### Quest Seeker Addendum for E80

The addendum was updated in 2015 for use of the Pnut altimeter.

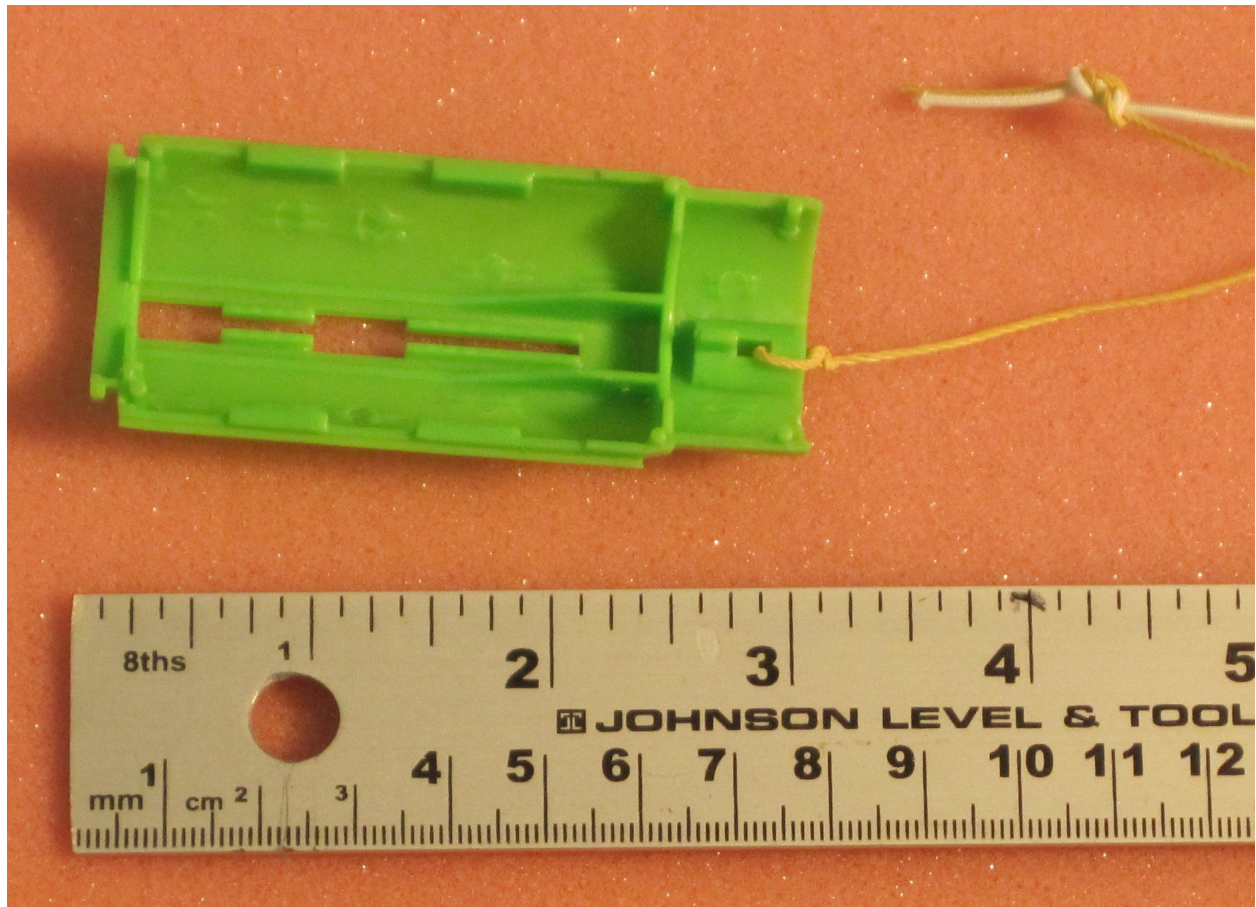
The on-line version of the instructions differs from the version included in the kit. The on-line version shows two parachutes, one attached to the body through the shock cord, and another attached to the payload section. You will also be attaching two parachutes: The one that came with the kit to the body and shock cord, and the smaller nylon one to the payload section. Your rocket should come down in two pieces, each with its own parachute.

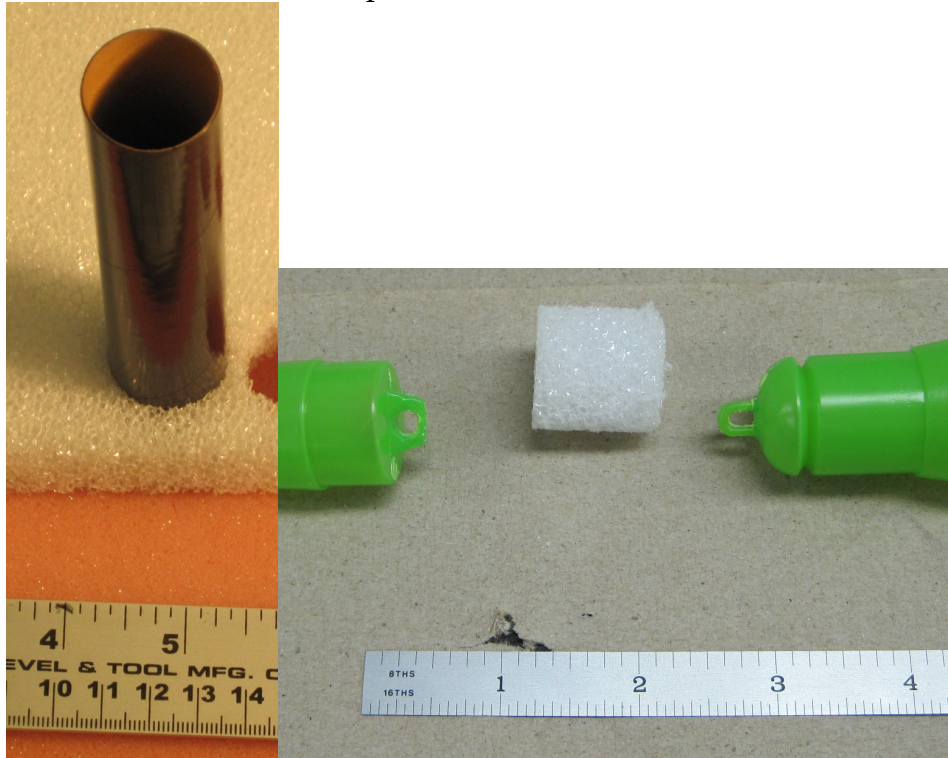
Replace Step 4 in the model instructions with the following steps:

1. Using a 1-inch-tube-punch (the stainless tube) or the Payload Tube, punch out two plugs of the 1-in thick white foam (one at a time). Rotate the tube as you push down. The white foam is roughly 1 in thick, is rigid, and comes in sheets. *Do not* use any other foam in the lab for this step.

2. Use a .5 in diameter (or larger) dowel or a large carriage bolt to push each plug back out of the tube.

Figure shows the two white foam plugs and two of the conductive foam plugs before assembly.

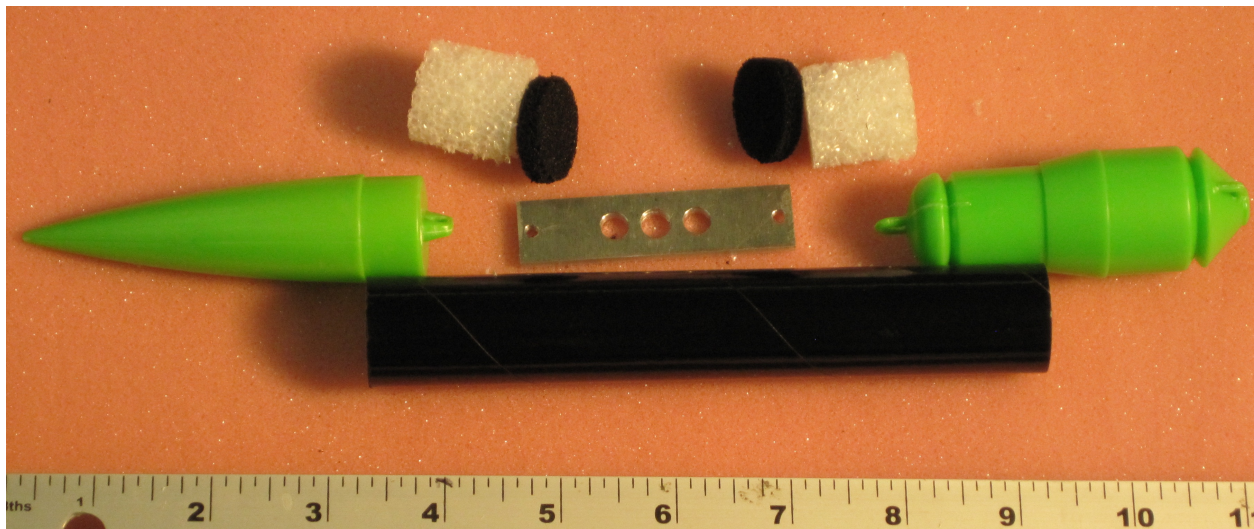
3. Carefully sand or abrade one piece of foam to reduce the diameter slightly, so that it fits easily in the Small Payload Tube. This piece will be attached to the Blow Mold Transition.

4. One piece of foam needs to be pushed onto the loop in the Nosecone, and the other onto the loop on the small end of the Blow Mold Transition. You can align them by hand if you are very careful, but it's easier to put the foam and the Nosecone or Blow Mold Transition into one end of the Small Payload Tube, put the .5 in dowel in the other end and push together until the loop penetrates the foam

Figure shows the assembled foam stacks with the altimeter simulator.

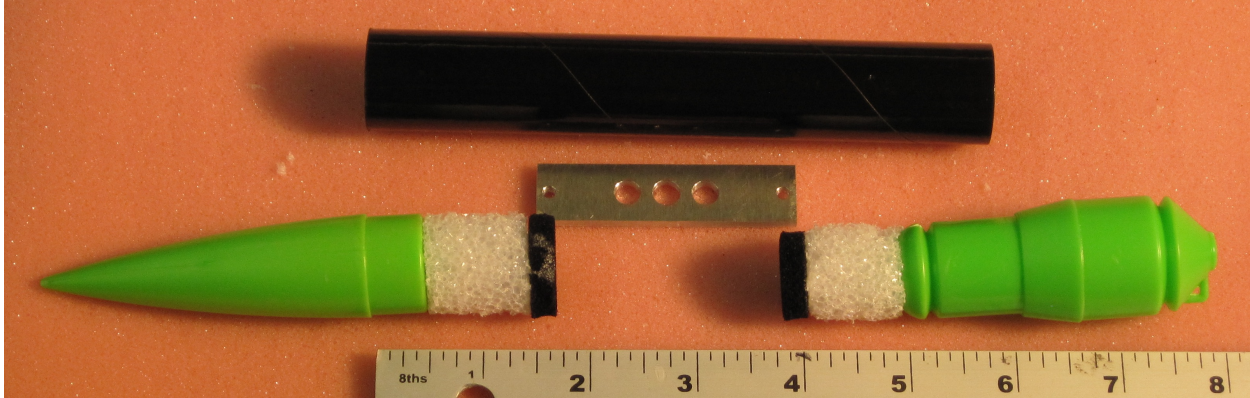
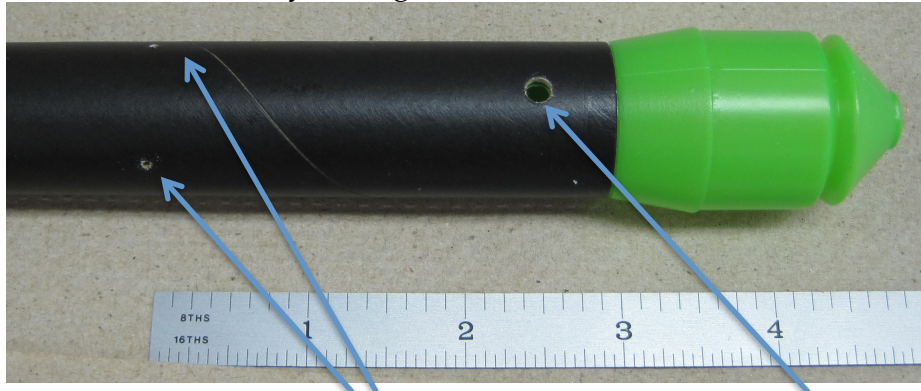
10. Use a generous amount of white glue and glue one of the remaining foam disks to the foam attached to the nose cone. The white glue takes a while to set. The completed assemblies should look like the photo below. The intent is that when assembled, the altimeter will be held in place by the two conductive foam disks.

Vent Holes

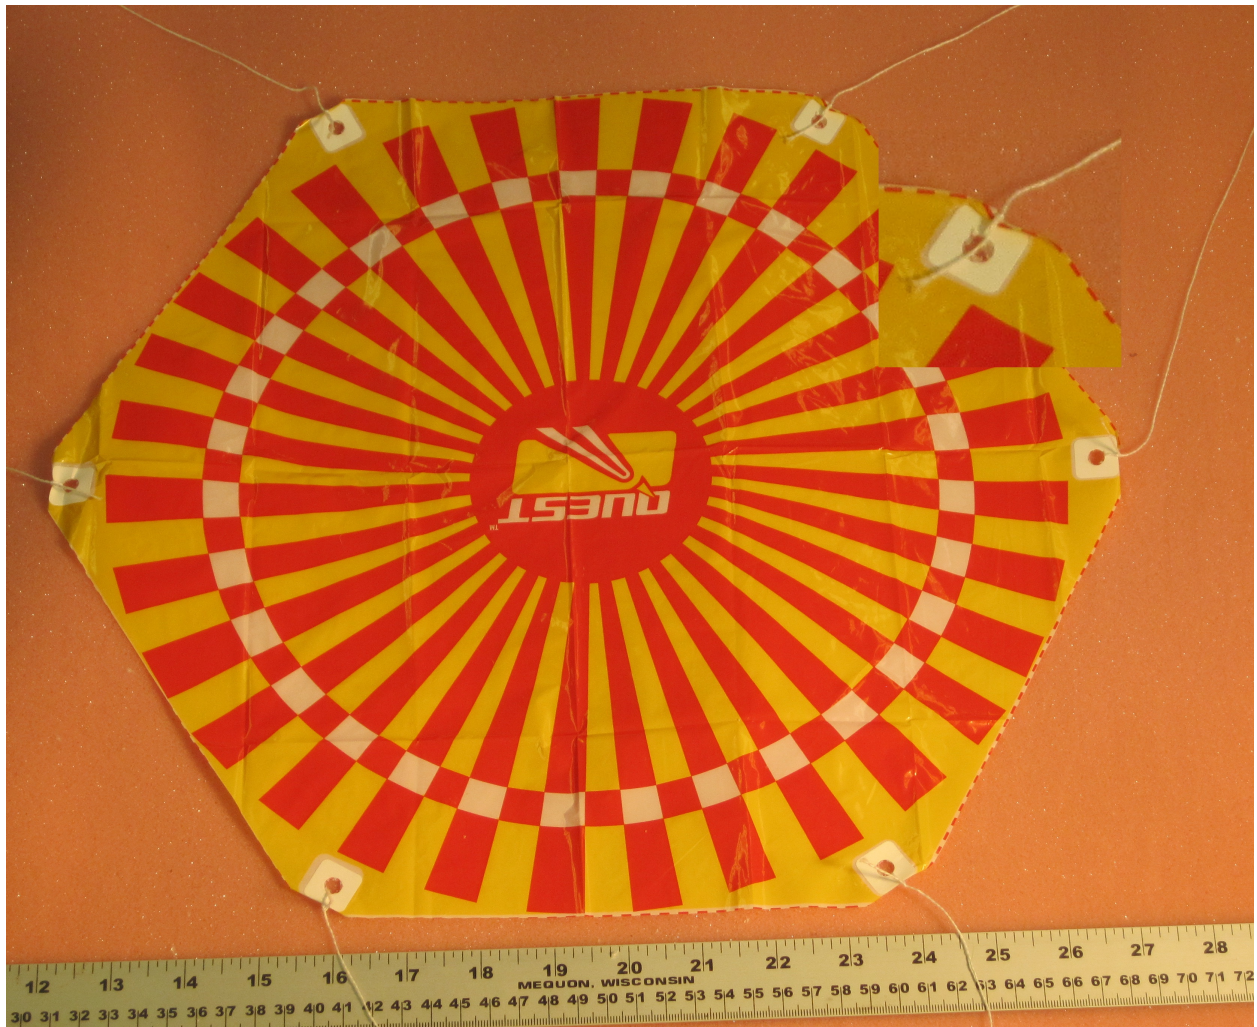
13. Insert the conductive foam – white foam – blow-molded-transition assembly into the payload tube. Drill holes for static vent  $3.00 \pm .25$  (or at a position you calculate) from the blow-molded-transition end of the Small Payload Tube. Holes should be spaced at  $120^\circ$  around the tube. Calculate the hole diameter from the [Adept Rocketry guidelines](#). Use the +100% size option. Do not make the holes smaller than .050 regardless of your calculations. Smaller holes plug too easily.

14. Drill a hole for a reusable plastic rivet. The hole should be  $.500 \pm .050$  from the end of the Small Payload Tube, and  $5/32''$  ( $.156 +.004/-0.000$ ) in diameter. Drill simultaneously through both the tube and the transition into the hollow center. **Do not** drill clear through the Payload Tube and out the other side. Be sure to use a plastic rivet in the hole for your launches. The plastic rivets are *reusable*. You should be able to reuse the same rivet for all of your flights.
